RECEIPT DATE: 9-30-21 **ONSITE SEWAGE DISPOSAL SYSTEM**

APPROVAL DATE: 10/22/2021 **PERMIT: CONSTRUCTION**

PROPERTY ADDRESS: 15625 LINDEN GROVE LANE, WOODBINE, MD 21797

SUBDIVISION: LINDEN GROVE, PHASE 1 LOT: 6 TAX ID: 04-601885

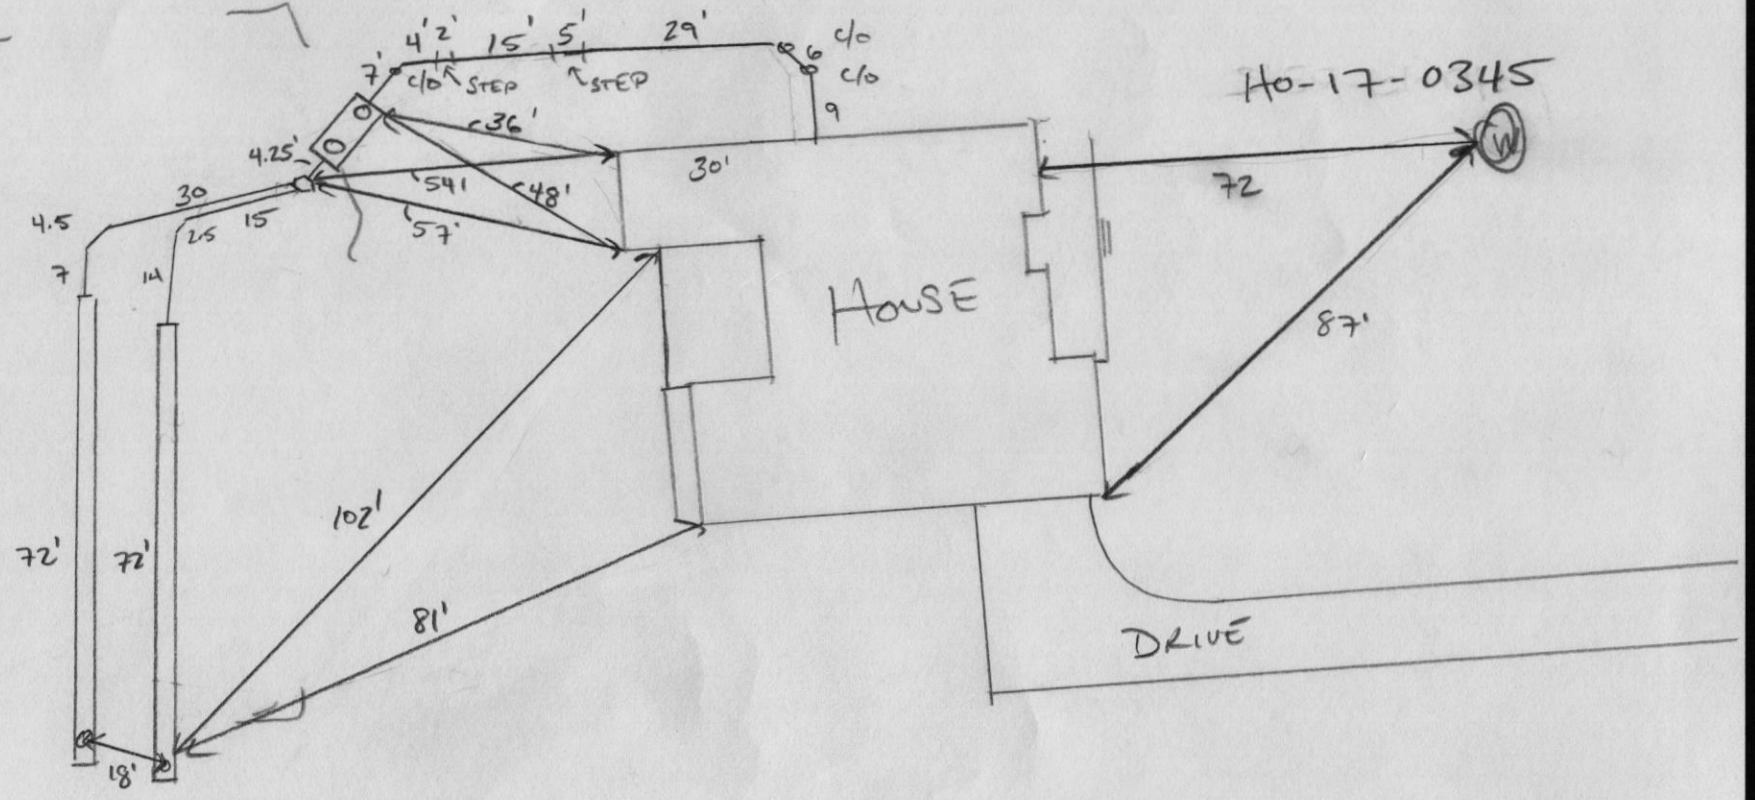
10/08/2021 CONFIRMED 2x70' TR STRAIGHTENED LOWER TRENCH w/ 6" DIFFERENCE. P

10/22/2021 INSTALLED SHC; TANK; DBOX - LEVELED w/ SPEED LEVELS; 2x72 TR. UPPER TRENCH IS 9' DEEP INLET 4.5' - SHOULD BE OK BASED OFF PERC 318 (DEPTH 13') - INSTALLATION PERSONNEL WAS NOT INFORMED BY LAYOUT PERSONNEL TRENCHES WERE STRAIGHTENED w/ 6" DIFFERENTIAL. CONTRACTOR TO CALL HEALTH BEFORE MAKING DESIGN CHANGES - INSTALLER IS NEW TO OSDS ~5 mo.
